# April 2018 Environmental Update for SLEMA Board

Zhong Liu  
April 30, 2018

# Time Series Plots of Mean Annual Total Phytoplankton Biomass in Snap Lake, Northeast Lake, and Lake 13, from 2004 to 2016

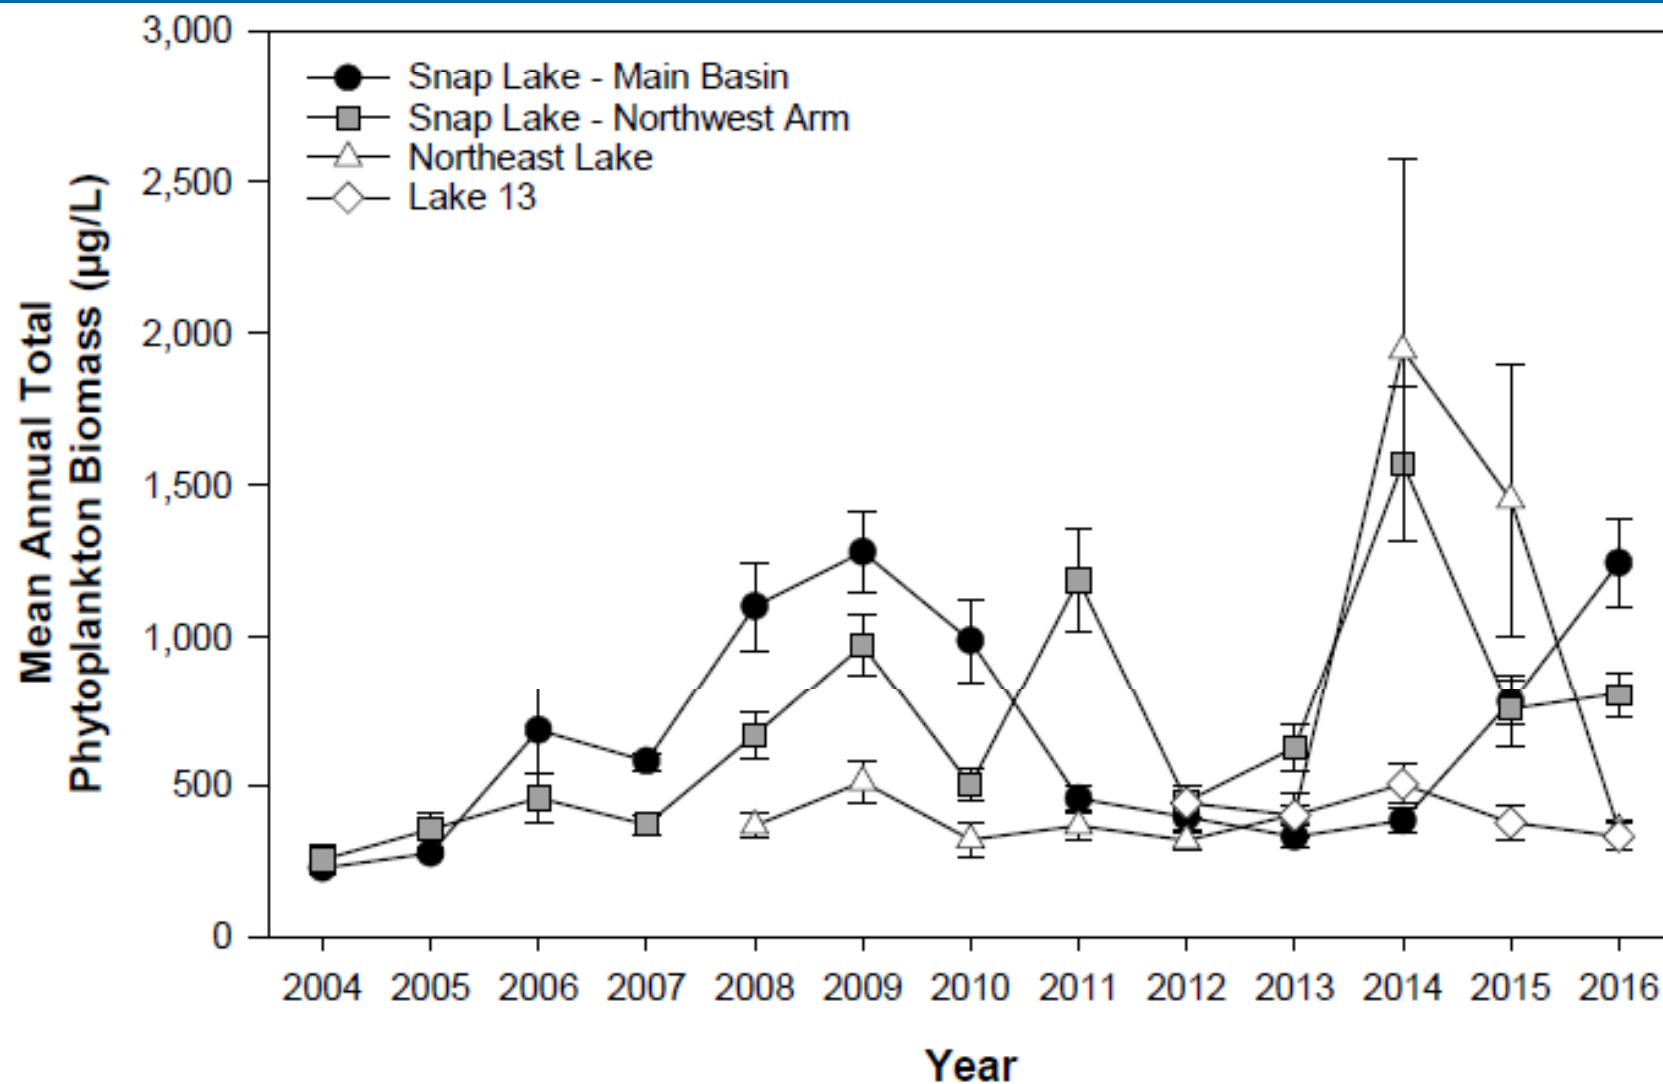
- Data of phytoplankton biomass in 2017 are not available yet, and are expected in May while Aquatic Effects Monitoring Program 2017 Annual Report will be submitted

# Monthly Runoff and Seepage from the North Pile, m<sup>3</sup>

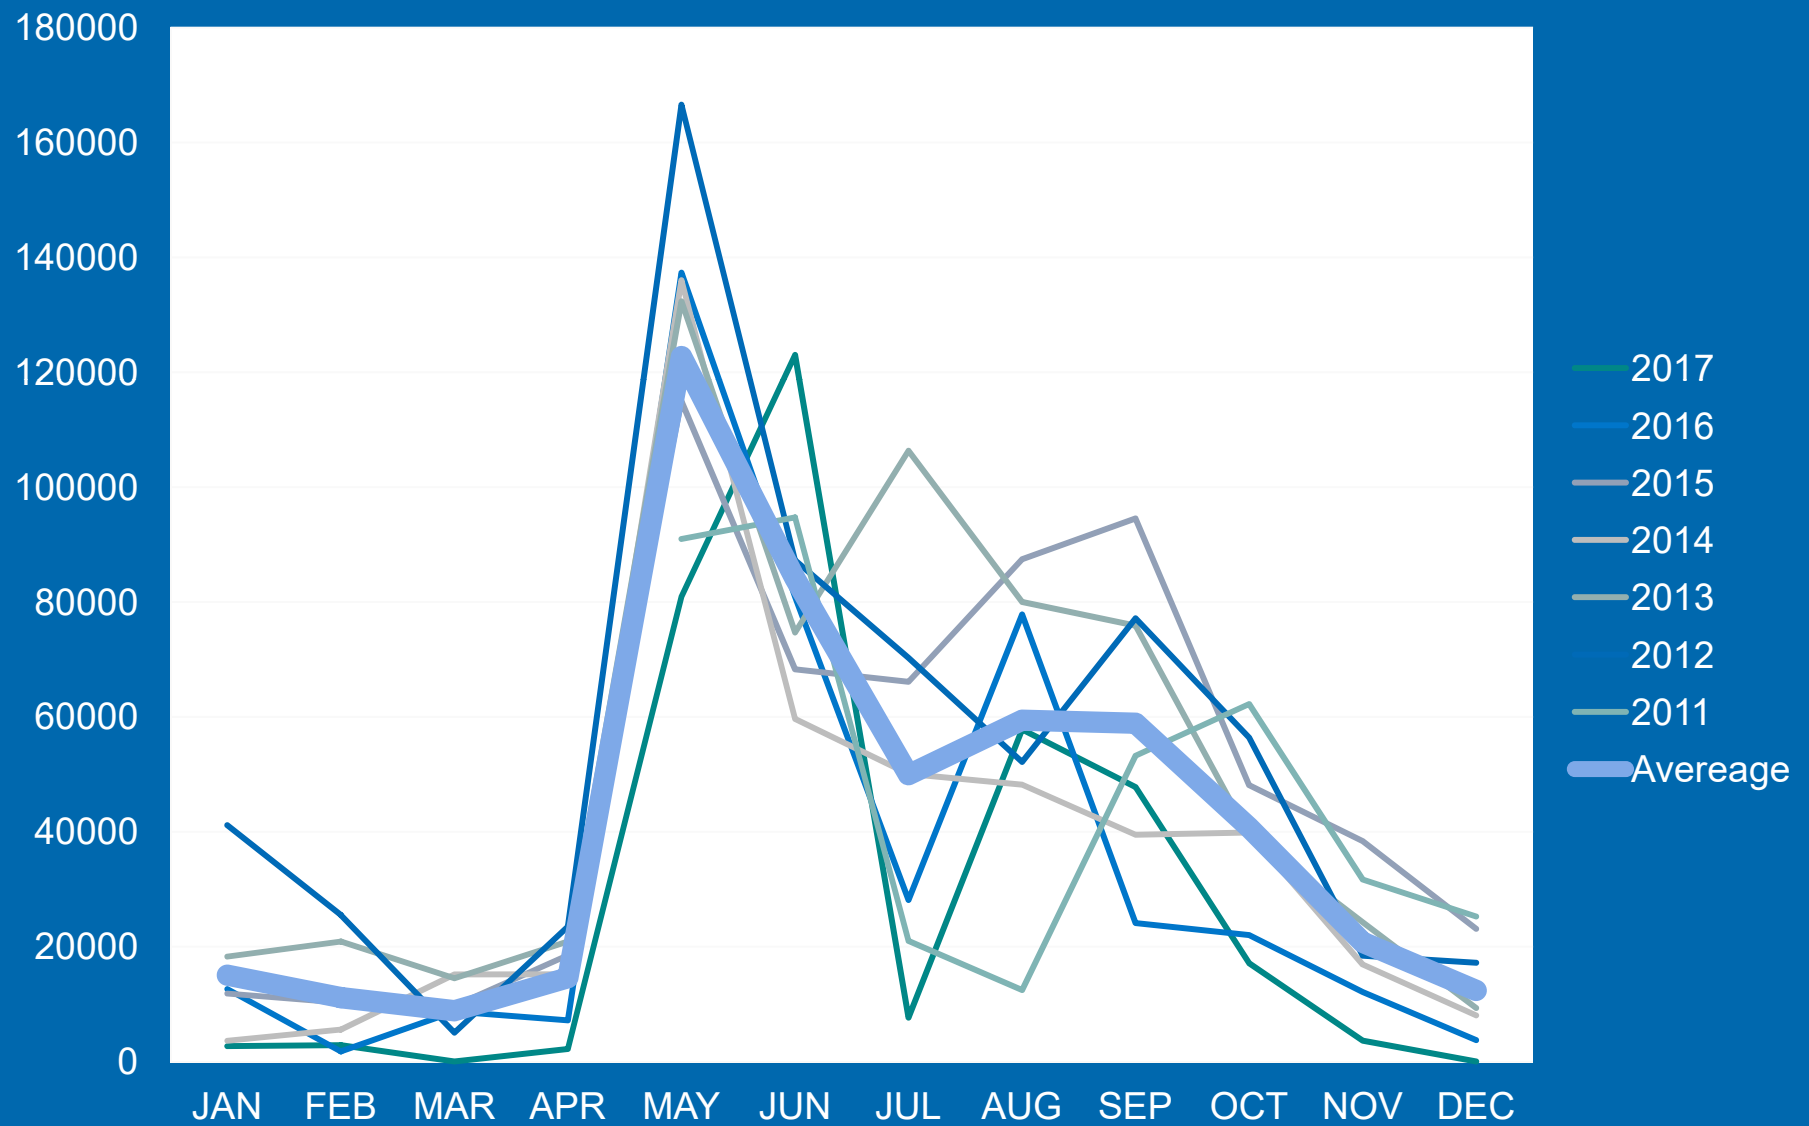
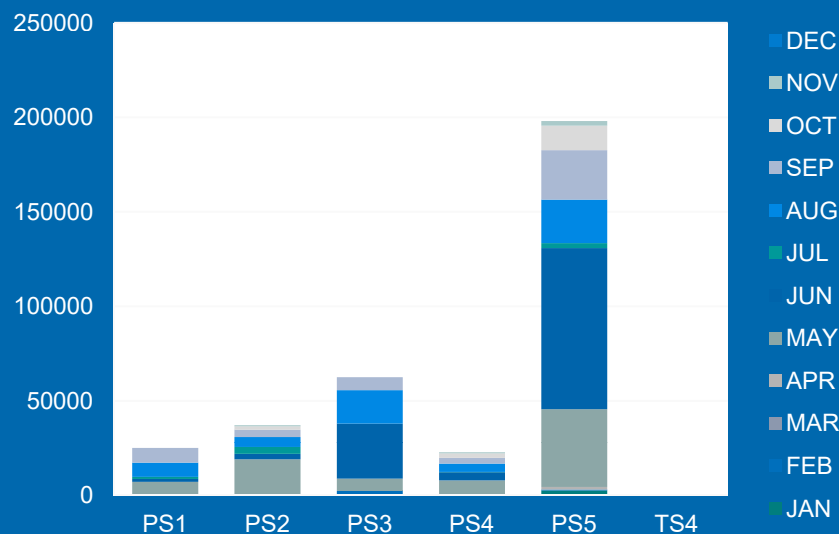
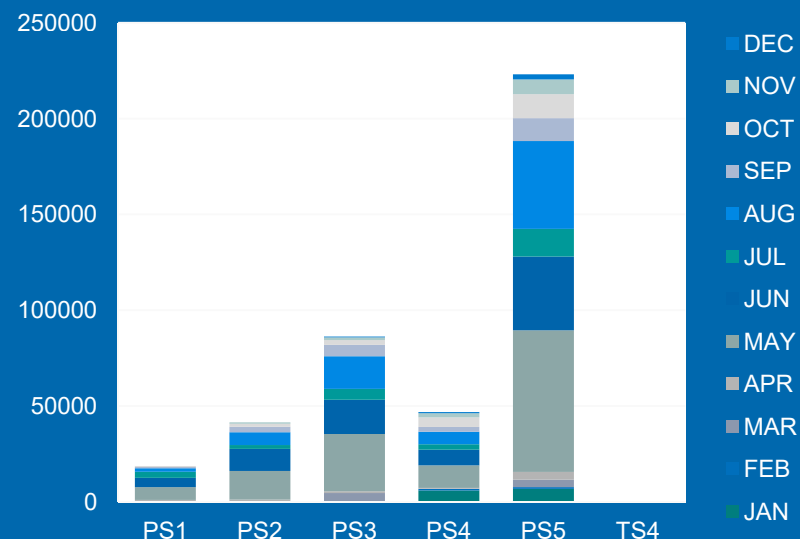
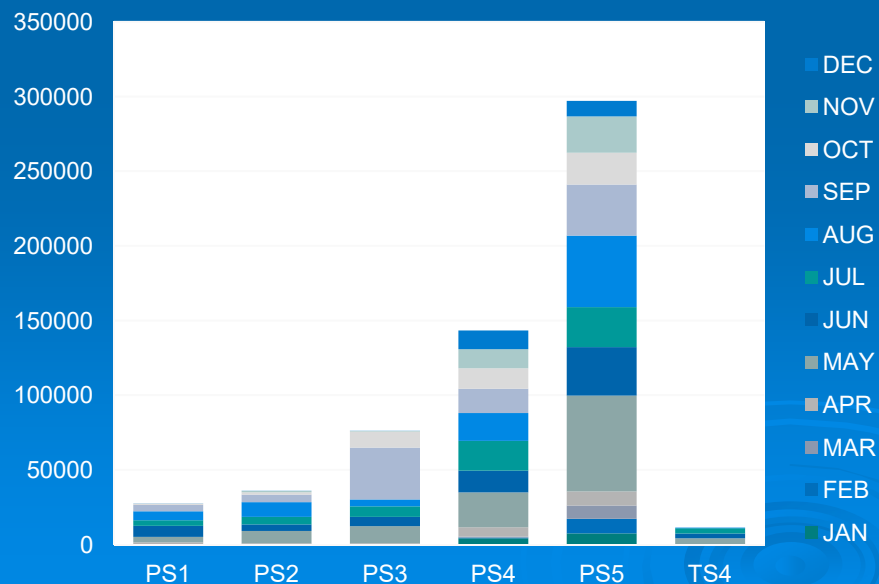
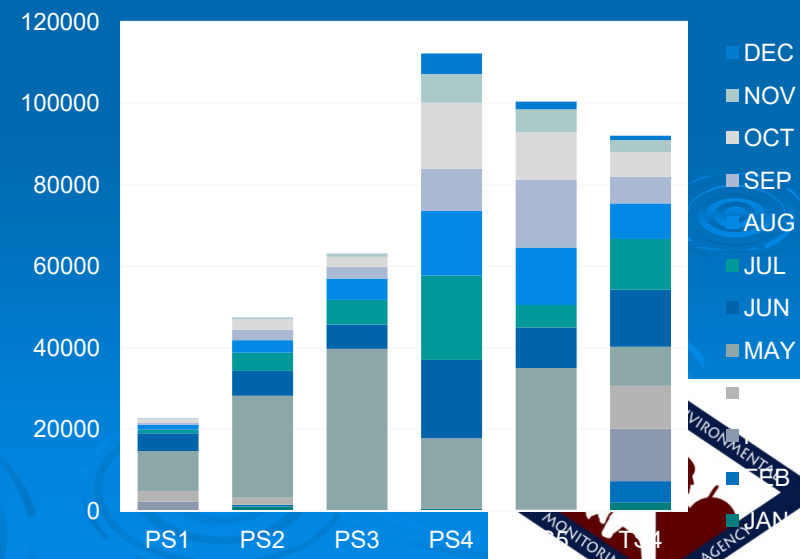
- North Pole runoff and seepage amount changes from year to year, ranging from 300,000 m<sup>3</sup> to 700,000 m<sup>3</sup> per year
- Runoff and seepage amount peaks during freshet period (May) and then goes down
- For the past three years Permanent Sump 5 (PS5) receives more runoff and seepage from the North Pole than other sumps

- Seepage and runoff should be actively managed from May to October
- For better understanding of the seepage and runoff quality, It is recommended that De Beers regularly takes samples from each of the active sumps
